SUITLAND FEDERAL
CENTER PARKING
STRUCTURE

SHEET LIST	SHEET NUMBER	SHEET NAME
	S0.0	COVER SHEET
	S0.1	GENERAL NOTES
	S0.2	GENERAL NOTES
	S1.0	ROOF PLAN - AREA A
	S1.1	ROOF PLAN - AREA C
	S1.2	LEVEL 4 - AREA A
	S1.3	LEVEL 4 - AREA C
	S1.4	LEVEL 3 - AREA A
	S1.5	LEVEL 3 - AREA C
	S1.6	LEVEL 2 - AREA A
	S1.7	LEVEL 2 - AREA C
	S1.8	LEVEL 1 - AREA A
	S1.9	LEVEL 1 - AREA B
	S1.10	LEVEL 1 - AREA C
	S2.0	REPAIR DETAILS
	S2.1	REPAIR DETAILS

No.	Date	Description
1116/2020	11/16/2020	Expansion Joint RFI Response

1 TYP. REPAIR DETAIL AT EXPANSION JOINT

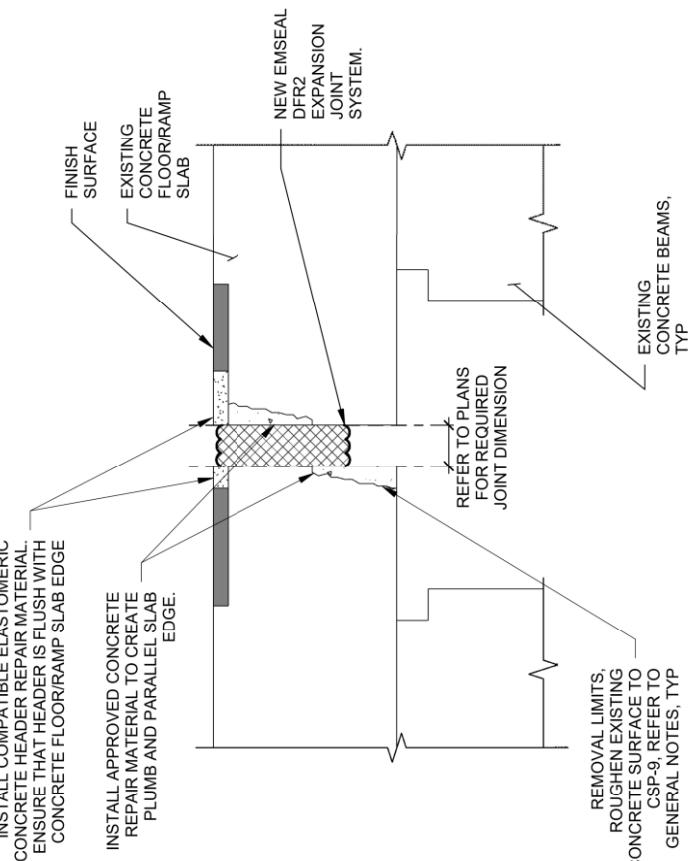
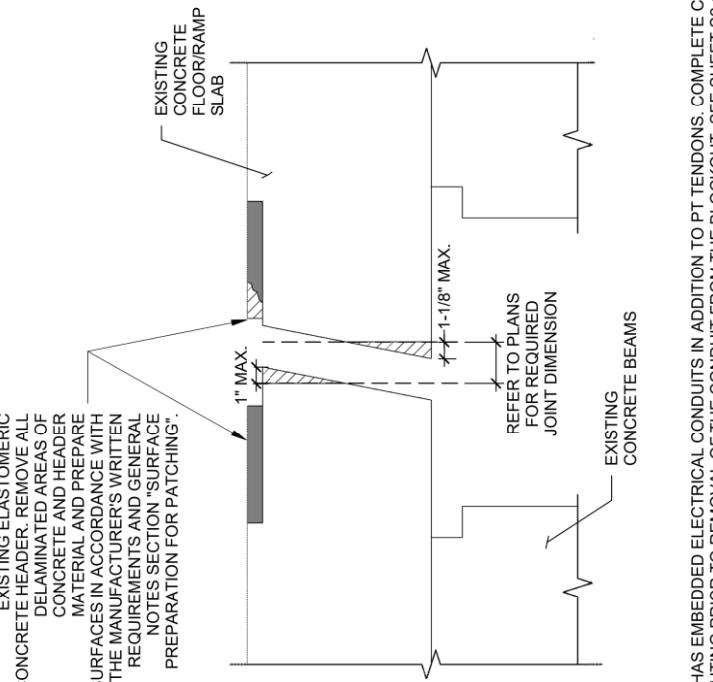
CAUTION:
1. SLAB HAS EMBEDDED ELECTRICAL CONDUITS IN ADDITION TO PT TENDONS. COMPLETE CONDUIT REROUTING PRIOR TO REMOVAL OF THE CONDUIT FROM THE BLOCKOUT. SEE SHEET S2.1 FOR CONDUIT REMOVAL AND REROUTE DETAILS.

- LOCATE ALL EMBEDDED ITEMS IN THE VICINITY OF THE EXPANSION JOINT BLOCKOUT USING NON-DESTRUCTIVE TESTING METHODS PRIOR TO PERFORMING CONCRETE REMOVALS TO MODIFY/REPAIR THE BLOCKOUT AT THE SLAB EDGES. REPORT ANY EMBEDDED MATERIALS DETECTED BY NON-DESTRUCTIVE TESTING METHODS THAT CONFLICT WITH CONCRETE REMOVAL OPERATIONS TO THE ENGINEER FOR REVIEW DO NOT DAMAGE POST-TENSIONING TENDONS/ANCHORS AND MILD REINFORCEMENT.

- WHERE REINFORCEMENT THAT IS EXPOSED DURING SURFACE PREPARATION IS FOUND TO BE SEVERELY CORRODED OR HAS LOST 15% OR MORE OF ITS CROSS SECTIONAL AREA, DESIGN OF SUPPLEMENTARY REINFORCEMENT.
